CITY OF ALBUQUERQUE

RE: **Lot 40 Block 3A Volcano Cliffs Unit 18 SAD 228**
6620 Kimmick Rd. NW
Grading and Drainage Plan
Engineers Stamp Date 3/1/18 (D10D003M2C)
Pad Certification Date 3/1/19

DRAINAGE AND TRANSPORTATION INFORMATION SHEET (REV 6/2018)

ENGINEER'S SEAL 3/1/19 DAVID SOULE P.E. #14522	6620 KIMMICK	DRAWN BY: WCMJ
	GRADING AND DRAINAGE PLAN	DATE: 3-01-19
	 1606 CENTRAL AVENUE SE SUITE 201 ALBUQUERQUE, NM 87106 (505) 872-5998	219013-LAYOUT-3-01-19
		SHEET #
		JOB # 219013

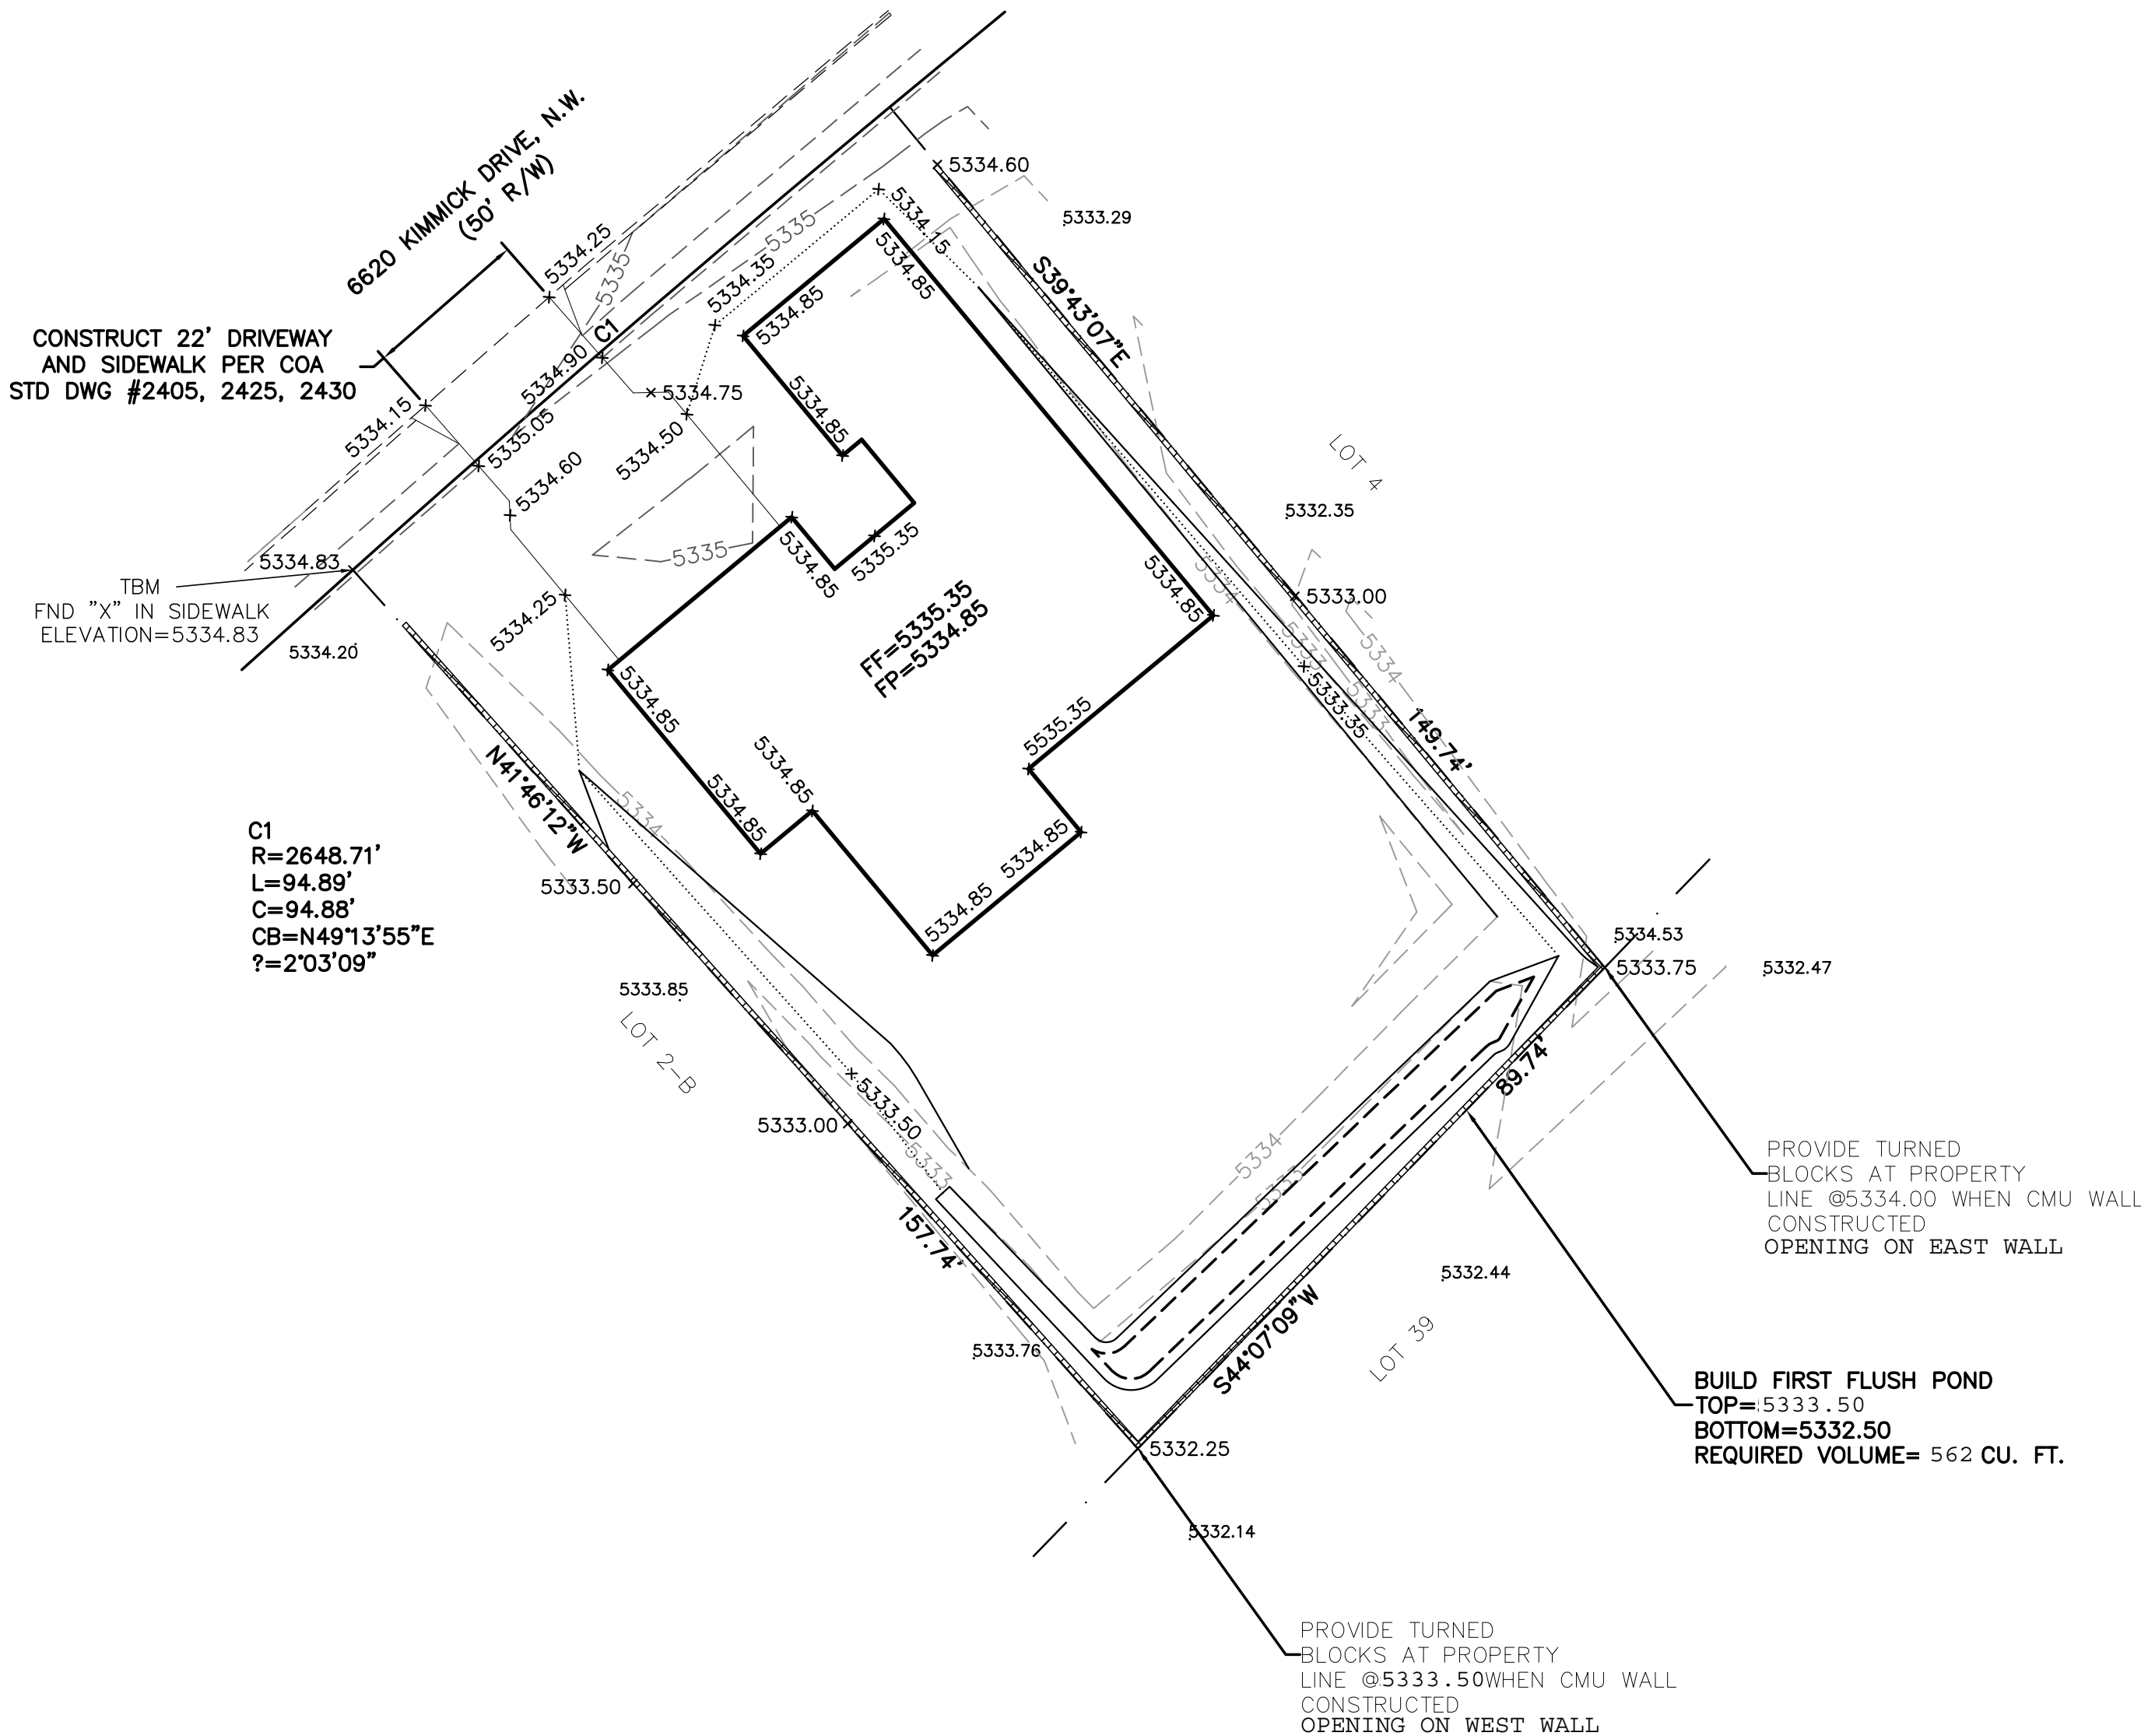
Based upon the information provided in your submittal received 3/1/19, this plan is approved for Building Permit.

Reiterate to the Owner/Contractor that a separate permit for a garden/retaining wall must be obtained, with the approved G&D plan dated 3/1/19.

Prior to Certificate of Occupancy release, Engineer Certification per the DPM checklist of this plan will be required.
